**City of Ryde Local Planning Panel Meeting No. 4/18**

**DEVELOPMENT APPLICATION**
**2 527 VICTORIA ROAD, RYDE - DEMOLITION OF STRUCTURES AND CONSTRUCTION OF A 3 LEVEL BOARDING HOUSE WITH boarding house with 19 BOARDING ROOMS - UNDER SEPP (AFFORDABLE RENTAL HOUSING) 2009 - LDA2018/0196**
**Report prepared by:** Senior Town Planner

| <b>Proposal</b>                    | <b>Demolition of structures and construction of 3 level boarding house with 19 boarding rooms</b> |

**Figure 7: Proposed building projection forward of neighbouring buildings highlighted in yellow and circled in red**

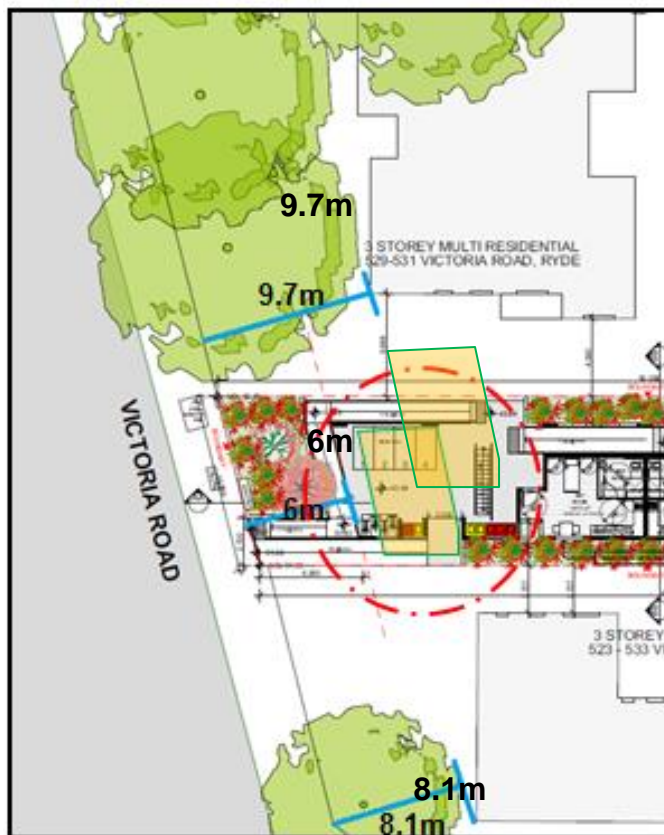
Secondly, the design of the development provides for only a 6m setback where the average setback of the adjoining properties is approximately 9.5m and 11.7m. The reduced setback of the building results in it projecting forward of the adjoining buildings by 4-5 metres, which can be seen in Figure 7. As there is no landscaping in the side setback of this portion of the building, the projection of the building bulk forward of the characteristic setback is not appropriately ameliorated. Whilst it is acknowledged that the existing building projects forward of the adjoining properties, it is a single storey building, not a three storey building as proposed.

Finally, the design of the development provides a flat roof and a front facade which is parallel to Victoria Road when the characteristic form of development in the vicinity of the site has a pitched roof form and is angled to the frontage such that the building is parallel to the rear boundary of the site. The design also provides an unattractive open undercroft element projecting forward of the adjoining buildings.

Figure 9: Longitudinal Section AA prepared by Ghazi Al Ali Architects (Drawing No. A-1401)

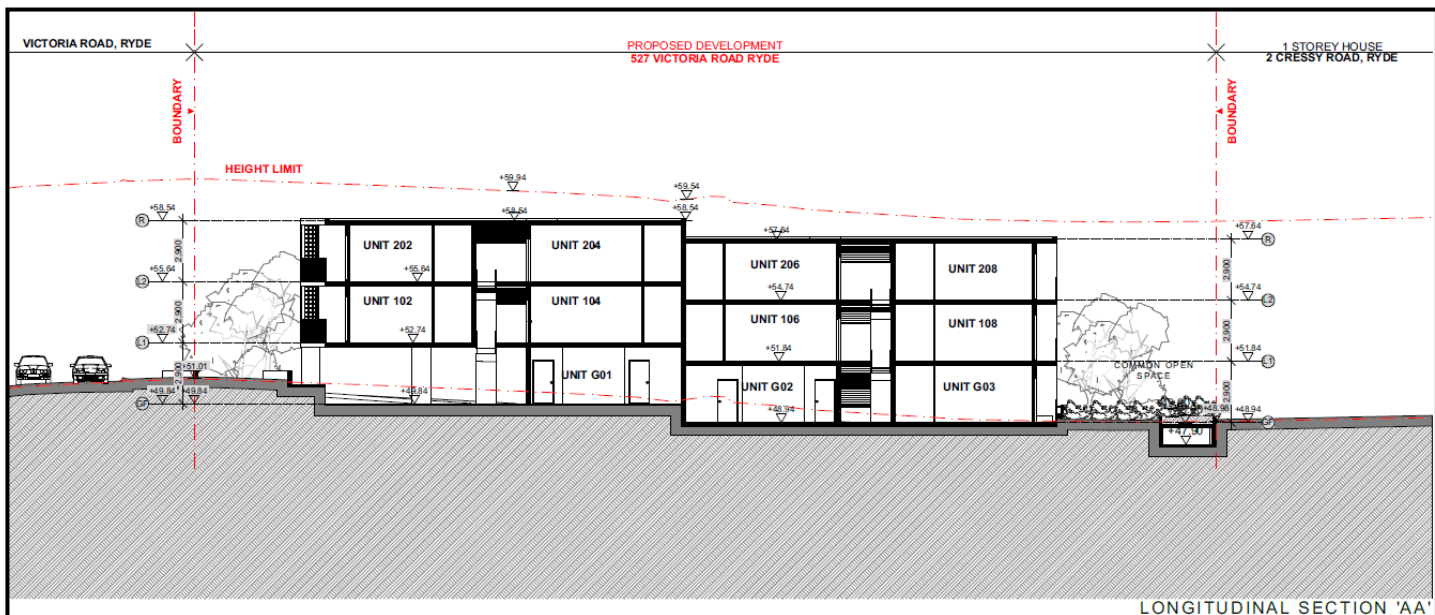
Clause 4.3 sets a maximum height control for the site of 9.5m. The proposal satisfies this control with a maximum height of 7.7m-9.39m at the front portion and 7.68m-8.99m at the rear portion as shown in Figure 9.

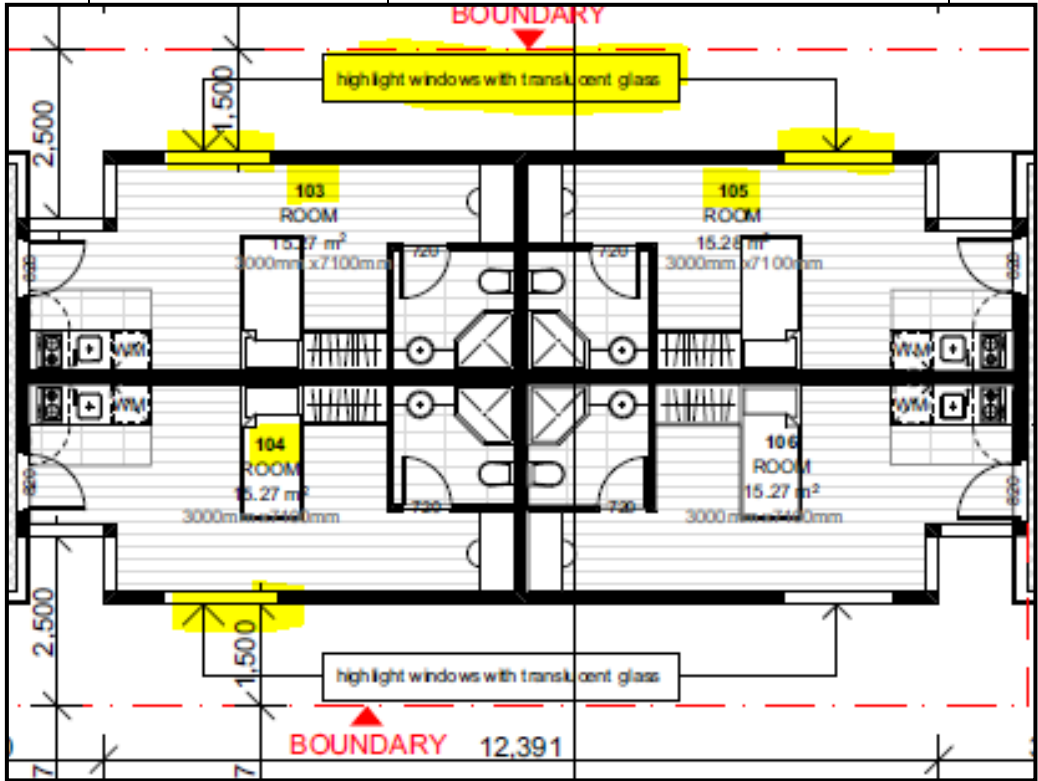
| Provision | Required | Proposed  | Complies |
|-----------|----------|---|----------|
|           |          | <p>example, the windows at the entry of a number of boarding rooms (103, 104, 105, 203, 204 and 205) will overlook windows of adjoining properties, inappropriately impacting upon amenity (see Figure 11 below).</p>    |          |

| Provision | Required | Proposed  | Complies |
|-----------|----------|---|----------|
|           |          | <p><b>Figure 11: Exert from Level 1 of affected rooms</b></p> <p>Any consent should include conditions requiring fixed privacy screens to the upper level balconies and a solid (ie not paling) fence to be provided along the rear fence to a height necessary to ensure no overlooking into the adjoining property can occur from the ground level boarding room, common room and common deck area. A privacy screen should be provided around the north-western and north-eastern sides of the deck.</p> |          |

**Figure 12: Solar access diagrams prepared by Ghazi Al Ali Architects (Drawing No. A-2011)**

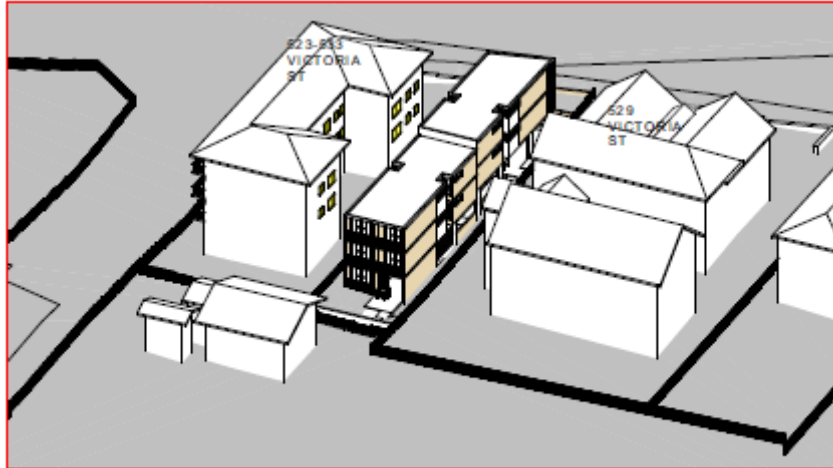
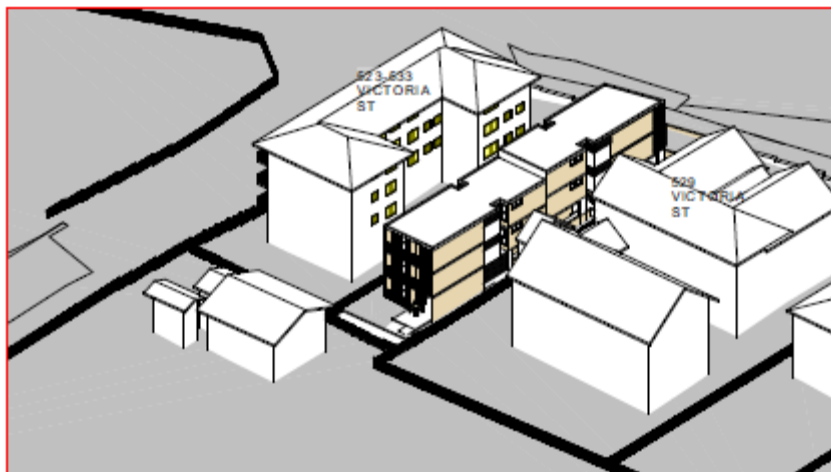
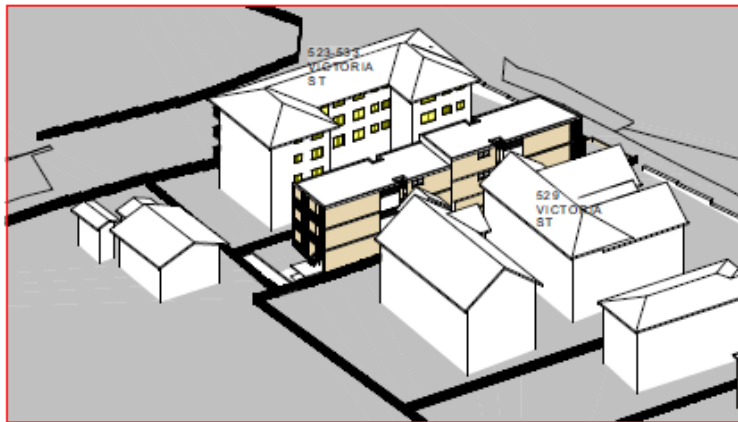
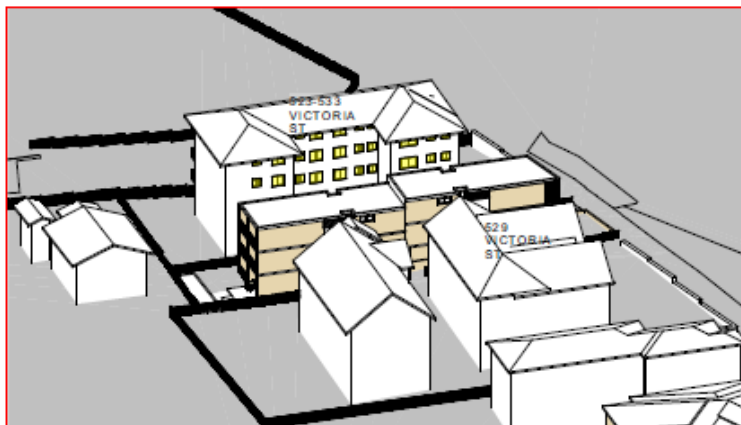
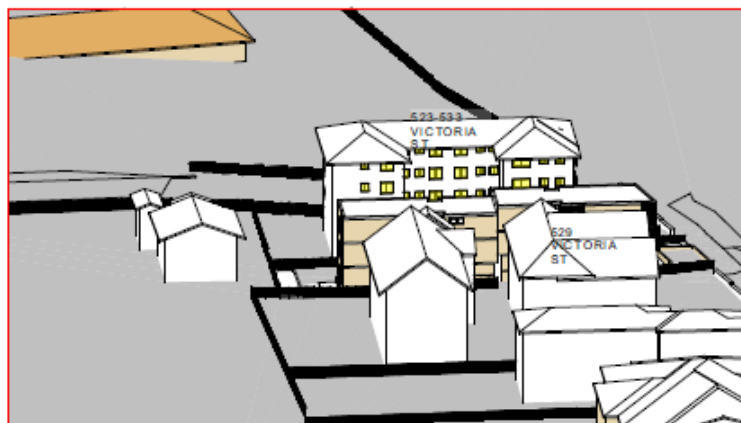
*Comment:* The proposal will reduce solar access to the adjoining apartment building (lower level) at 523 Victoria Road to approximately between 2 and 2 ½ hours to the windows along the southern side of the

building (between the hours of 11am and 3pm, with the exception of the middle portion of the building having a greater setback. These windows will achieve a minimum of 3 hours solar access during winter as illustrated in Figure 12.
